Date: January 10, 2023

From: Audubon Society of Portland, Cascadia Wildlands, Coast Range Forest Watch, Wild Salmon Center, Western Environmental Law Center, Umpqua Valley Audubon Society, Audubon Society of Lincoln City, Lane County Audubon Society, Kalmiopsis Audubon Society, Salem Audubon Society, Audubon Society of Corvallis, Oregon Wild, Cape Arago Audubon Society, Center for Biological Diversity, Humane Voters Oregon, Oregon League of Conservation Voters, The Larch Company and The Conservation Angler

RE: Elliott State Research Forest November 2022 draft EIS

Docket No. FWS–R1–ES–2022–0029

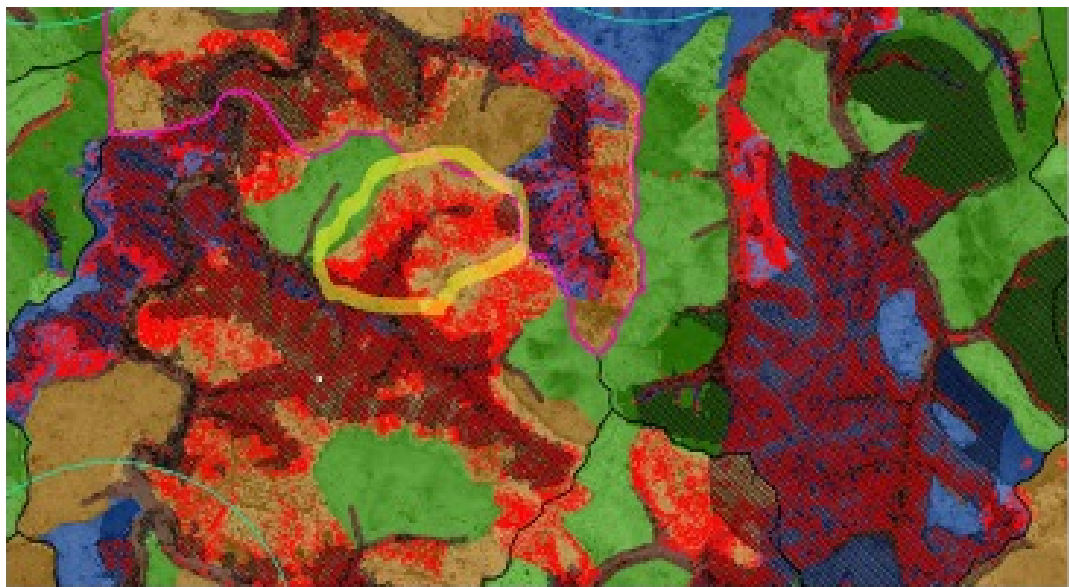
We have included an example from OSU's watershed maps that exemplifies this concern below. Note the area encircled in yellow. The hatch marks (darker area) show modeled Marbled Murrelet habitat following what appears to be a stream corridor. However, the red dots, representing large old trees, extend far beyond the modeled Marbled Murrelet habitat. Under the Pacific Seabird Group Protocol, if murrelets are found anywhere within a contiguous stand of trees, then the entire contiguous stand should be designated as occupied Marbled Murrelet habitat. Thus, if OSU's modeling shows Marbled Murrelets occurring anywhere within a contiguous stand of trees, then the model should designate the entire stand of trees as occupied. It would be entirely inconsistent with the PSG Protocol to designate a narrow strip within a large stand of older trees as modeled habitat but leave the rest of the stand undesignated. There are several other examples of this flaw within this screen shot, and we have found multiple additional examples on other maps provided by OSU.

It is unclear how significant this modeling error is within OSU estimates for modeled habitat. However, upon preliminary review, it does appear to be quite pervasive. We have requested that OSU address this concern, but have not heard back from them at this point. The take home is that OSU's modeling of potential habitat may significantly underestimate the amount of potential Marbled Murrelet habitat and thus the amount of potential take of Marbled Murrelets that

We strongly urge USFWS to ensure that 1) data sets of occupied marbled murrelet habitat are complete, 2) all Marbled Murrelet habitat has 100 meter buffers, and 3) modeling of potential habitat conforms to the PSG Protocol recommendations (includes contiguous habitat).
